ADDENDUM NO. 1

ISSUE DATE: **September 05, 2024**

RE: **CHAMBERLIN L&S SONGS PHYSICS LAB RENOVATION
UNIVERSITY OF WISCONSIN-MADISON
MADISON, WISCONSIN**

UW-Institution Project No. 0055-2346
UWSA Project No. A-23-012

1 DEMOLITION PLAN - LEVEL 03
Scale: 1/4" = 1'-0"

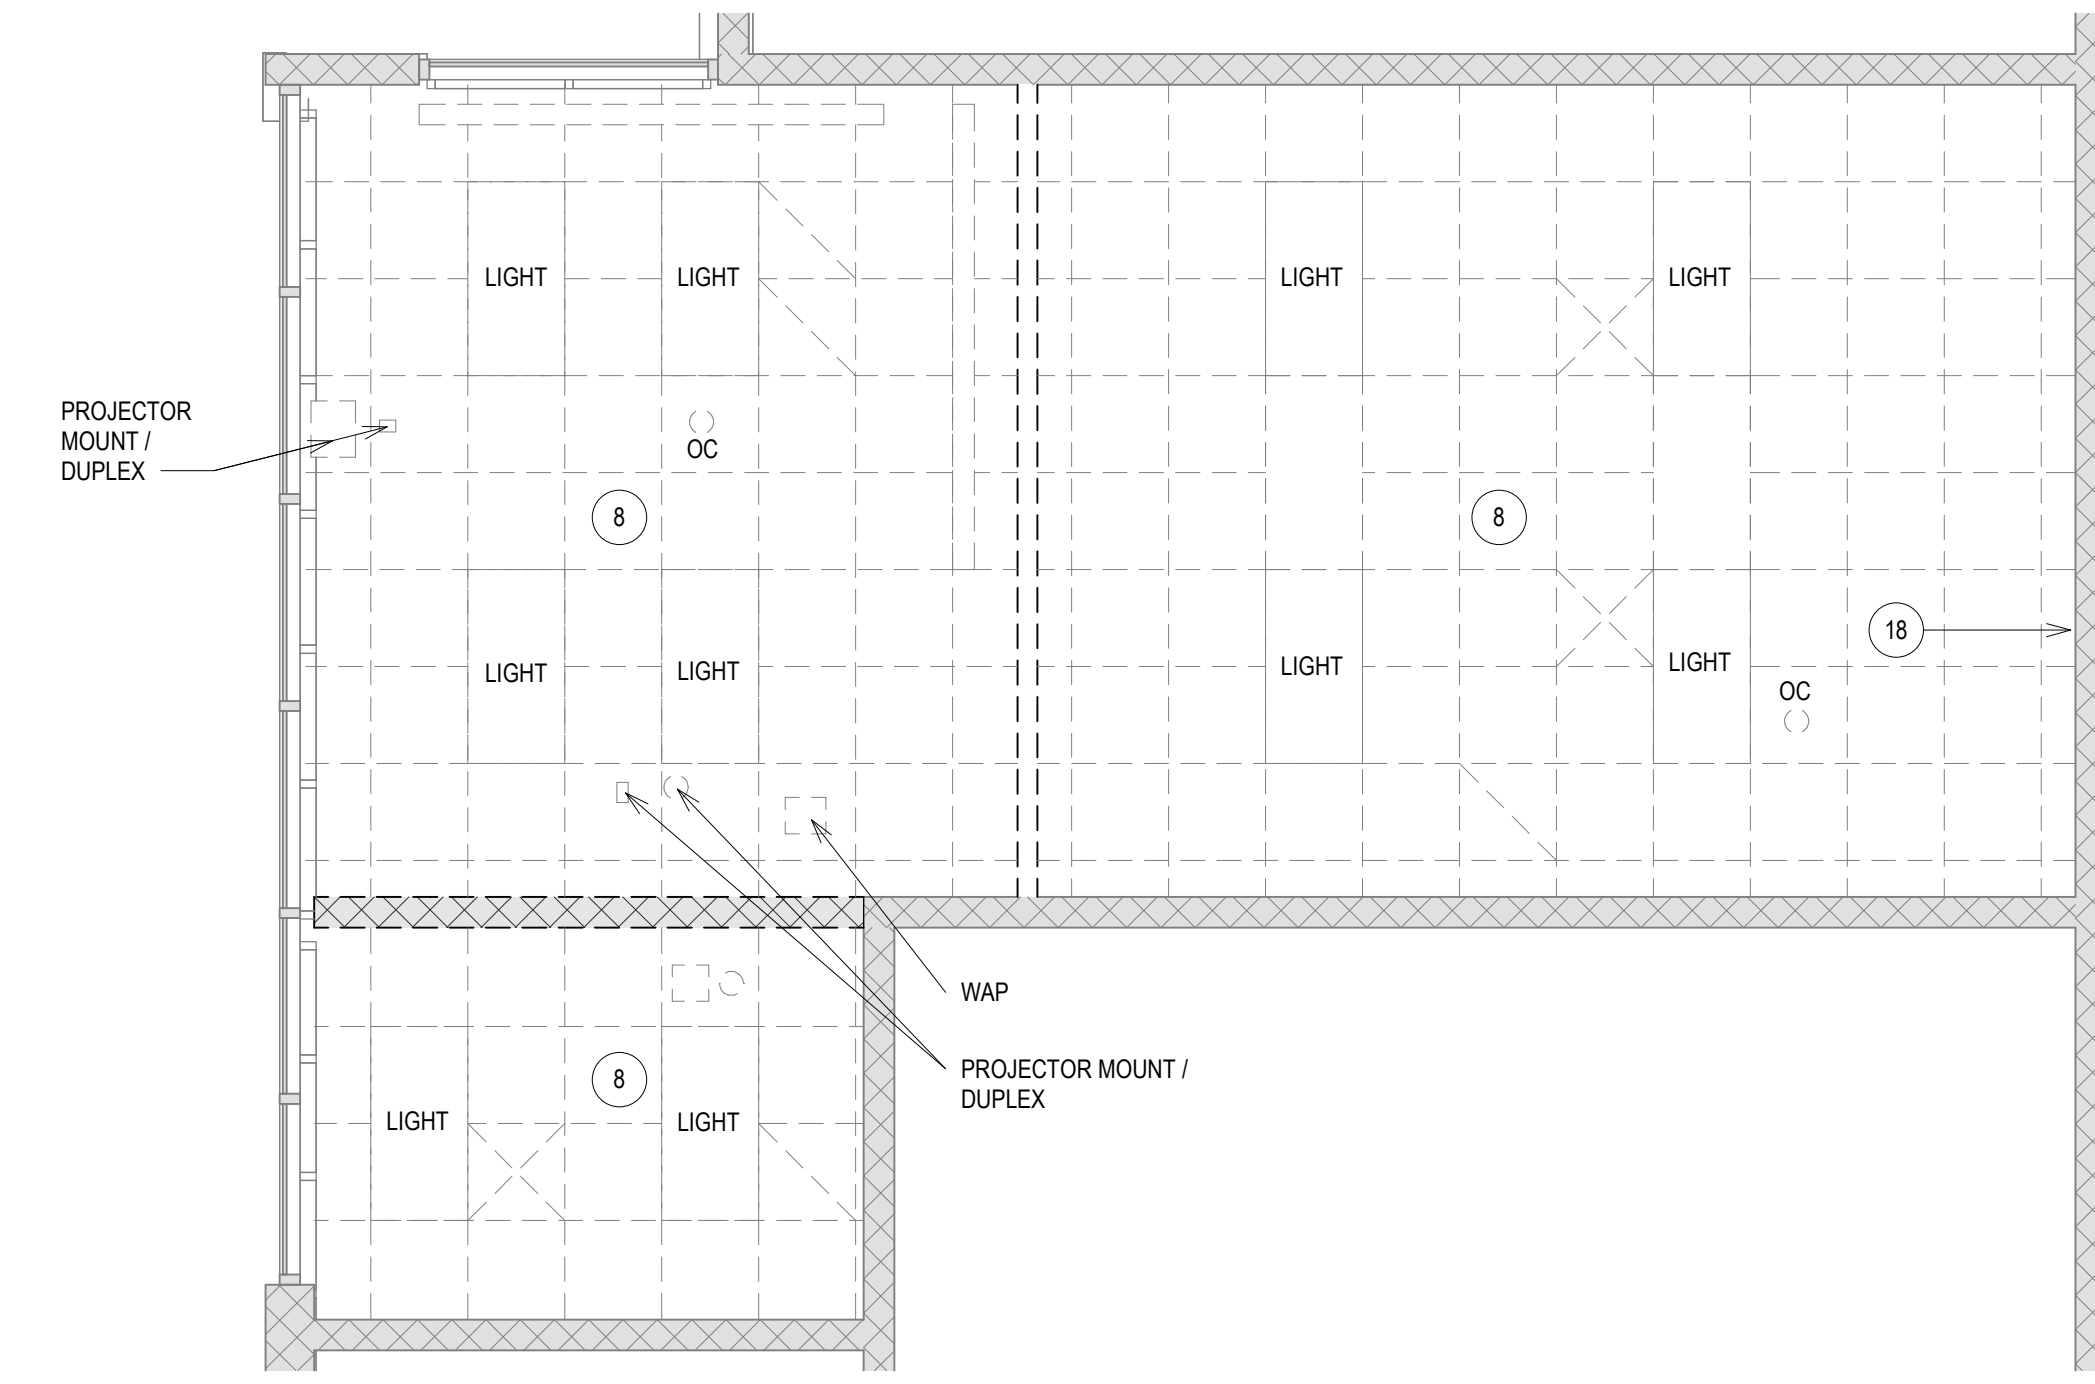
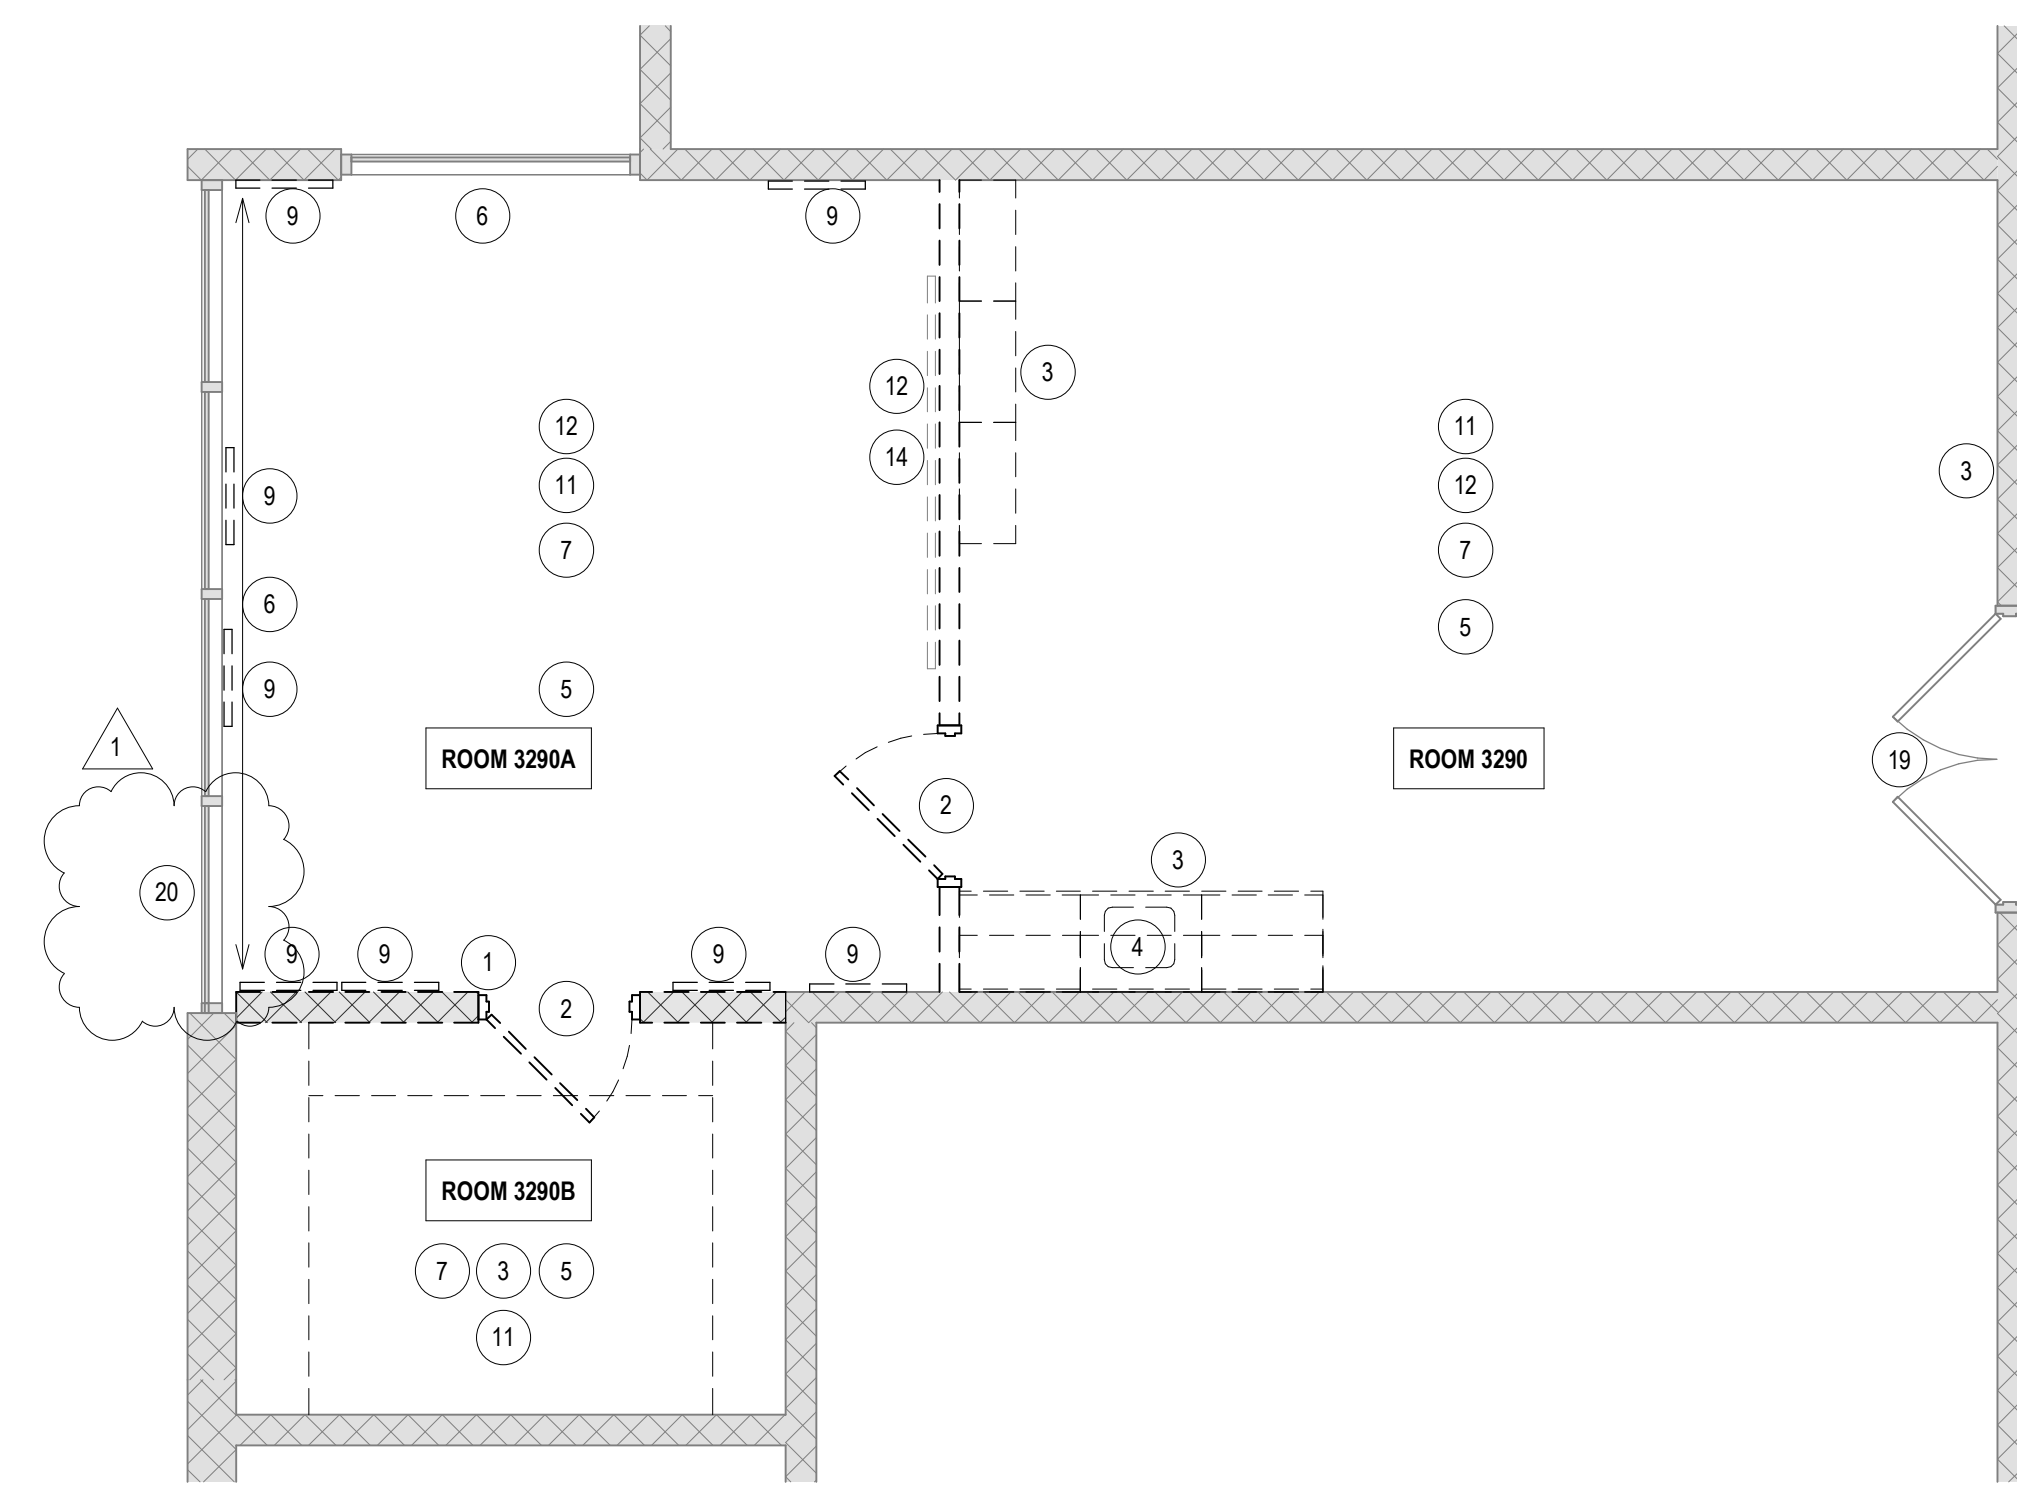
1. Sheet A101 – DEMOLITION PLAN – LEVEL 03
 - a. Add demolition plan keynote 20.
2. Sheet A102 – DEMOLITION PLAN – LEVEL 04
 - a. Add demolition plan keynote 20.
3. Sheet E201 – NEW WORK PLAN – LEVEL 03 - ELECTRICAL
 - a. Revise power general note to clarify the number of current carrying conductors allowed to be installed in a single conduit prior to conductor derating.
4. Sheet E211 – NEW WORK PLAN – LEVEL 04 - ELECTRICAL
 - a. Revise power general note to clarify the number of current carrying conductors allowed to be installed in a single conduit prior to conductor derating.
